W- 3637 Griffith RD C-Store (Special Use Rezoning from RS9 to LB-S)

Project Name: W- 3637 Griffith RD C-Store (Special Use Rezoning from RS9 to LB-S)
Jurisdiction: City of Winston-Salem
ProjectID: 1456826

Wednesday, November 20, 2024

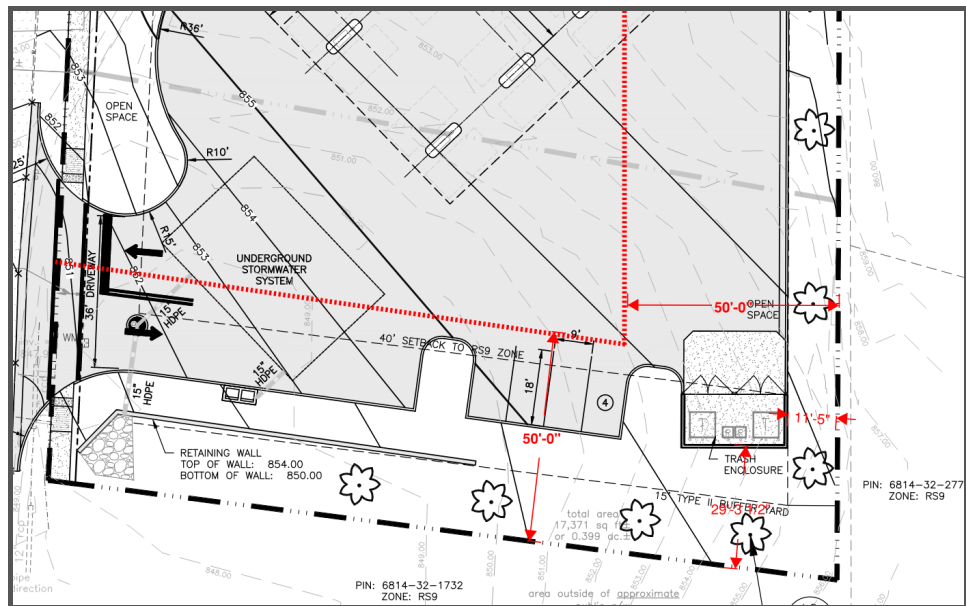
UDO Section 4.1.4.C.4

All air handling machinery, dumpsters, compressors, or water coolers for nonresidential uses shall be set back a minimum distance of fifty (50) feet from any property line adjacent to residential uses or residentially zoned land.

The dumpster will need to be moved somewhere else on site.

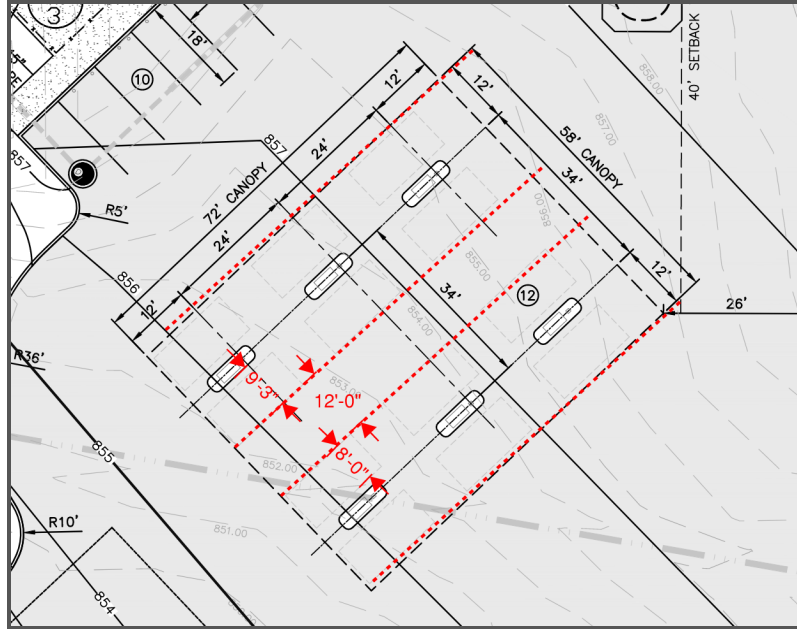
- N/A.
 - **Pedestrian Walkway:** All of these developments, when located with vehicular access onto a street classified as a sidewalk-designated collector, minor thoroughfare or major thoroughfare, shall provide a physically separated and unobstructed paved pedestrian walkway a minimum of five (5) feet in width between a principal building entrance and each sidewalk-designated public street.

- **A pedestrian connection to Burke Mill is currently proposed.**
 - **However, a direct pedestrian connection to Griffith Road is also**

required.

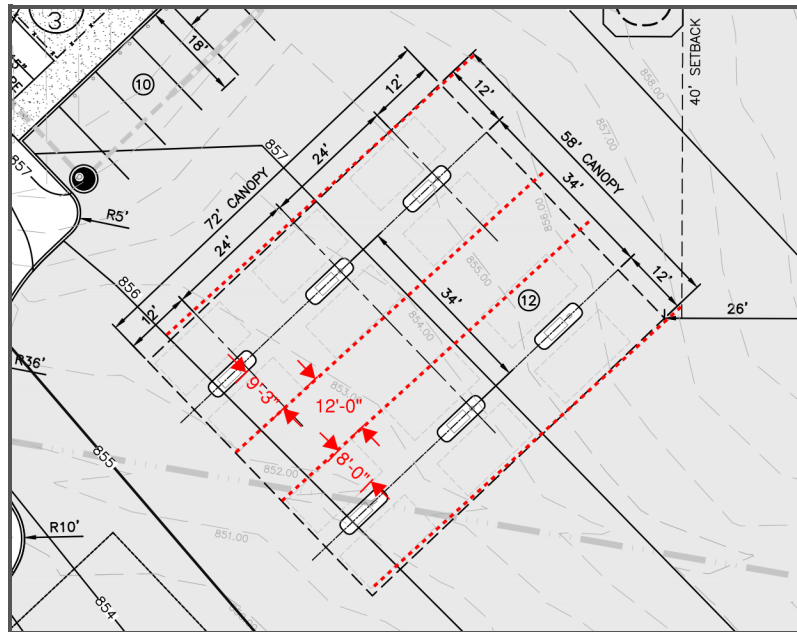
- All parking areas shall be designed and constructed to meet minimum parking space dimensions, aisle dimensions, and other standards shown in Table 6.1.3B, Parking Dimensions, and Figure 6.1.3B.1, Parking Dimensions.
- All parking dimensional requirements are currently being met.
- The drive aisle underneath the gas canopy needs to be demarcated and be 12' wide. See below:

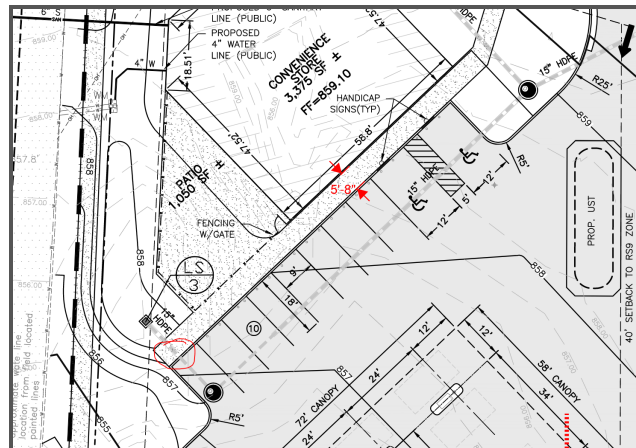
- In consultation with the Deputy Director, we will be counting the gas canopy parking spaces as "Drive-Through Facility Stacking Lanes" in the UDO. Stacking lanes requires that "Each lane of stacking space shall be a minimum of nine (9) feet in width

and must be delineated with pavement markings." Please delineate the gas canopy parking spaces in a manner of your choosing to show a clear separation between the gas canopy spaces and the drive aisles surrounding them. A general idea is shown below:

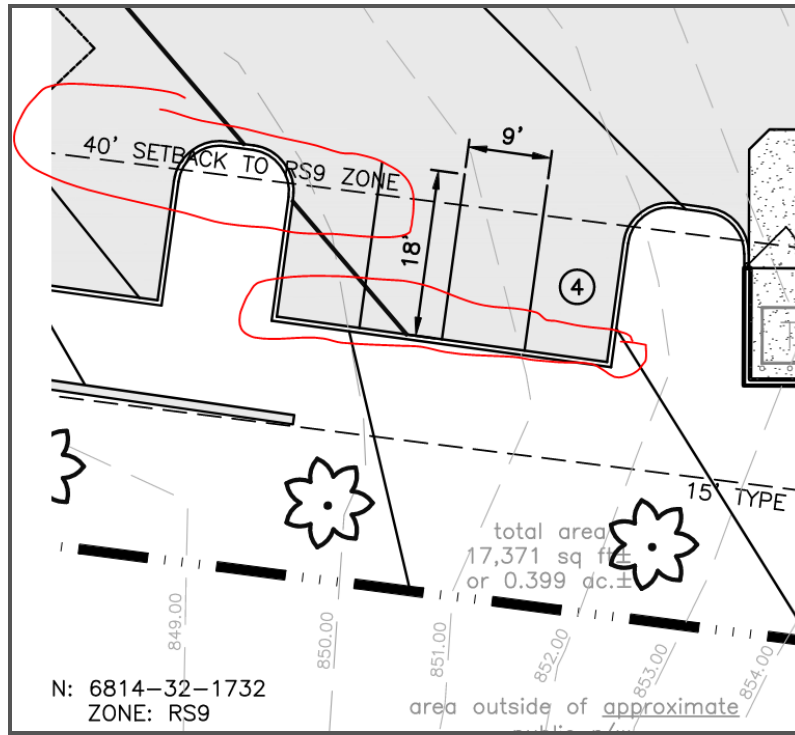
The following parking spaces are located within the 40' setback. Required setbacks create required yards.
